Subject: EPA Comments on Alliant Energy, Interstate Power & Light Co - Sixth Street Generating Station, Cedar Rapids, IA
Round 10 Draft Assessment Report

**Re: Response to Draft Assessment Report
Sixth Street Generating Station**

Response
USEPA Draft Report
Safety of Coal Combustion Waste Ponds
6th Street Generating Station
Cedar Rapids, Iowa

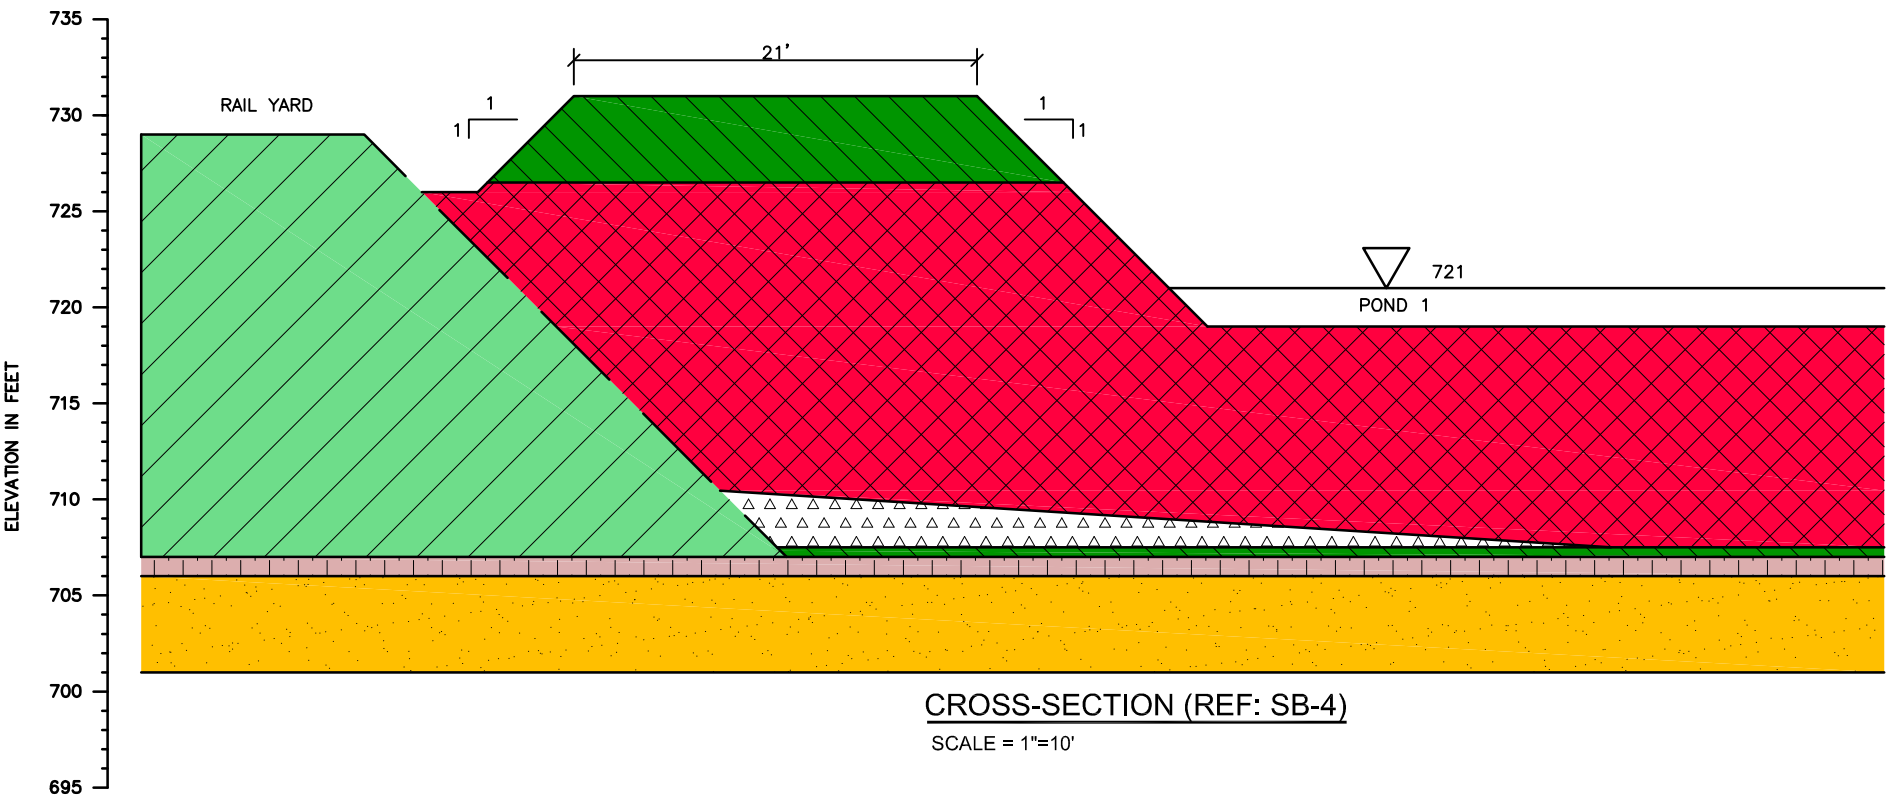
When the borings were installed in June 2011, the approximate geometry of the embankment at each boring location was measured by Aether. Figure 1 shows the field measurements of the crest width, upstream and downstream slopes and the location of the adjacent pond water at SB-3 (Pond 4) and SB-4 (Pond 1). The measurements show that

the crest widths in the higher sections of the embankment range from 15 to 30-foot. The inboard and outboard slopes are as steep as 1H to 1V on some slopes (The steep slopes are covered with rip rap, Photograph 2). From these variations, Aether chose to analyze the highest embankment near the outlet of Pond 4 where the crest was at the minimum width of 15-feet and the toe of the slope is at the water surface of Cedar Lake at elevation 721.

Slope Stability Analysis Results Ten Most Critical Surfaces Per Analysis

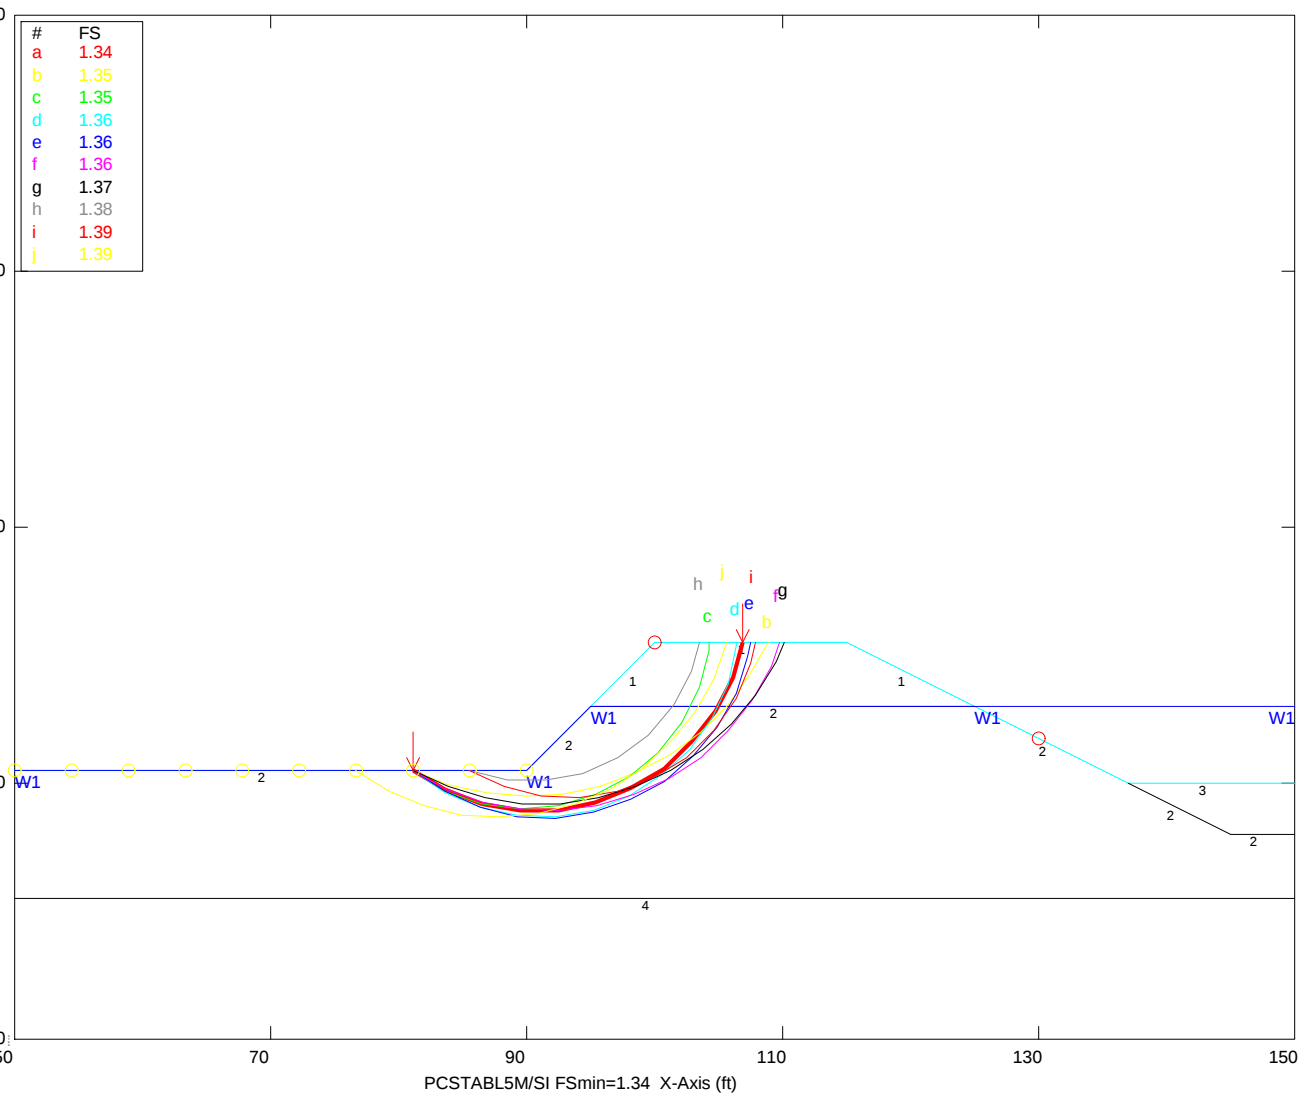
An extended analysis of the cross-section of the embankment on Pond 4 presented by Aether³ in 2011 is shown in Attachment B. The result was completed by increasing the phreatic water elevation in the embankment cross-section to saturate the entire thickness of the coal combustion waste. The factor of safety under this rapid drawdown type of loading condition is 1.3. The result shows why the ponds were not structurally impacted by the recession of the 2008 flood inundation.
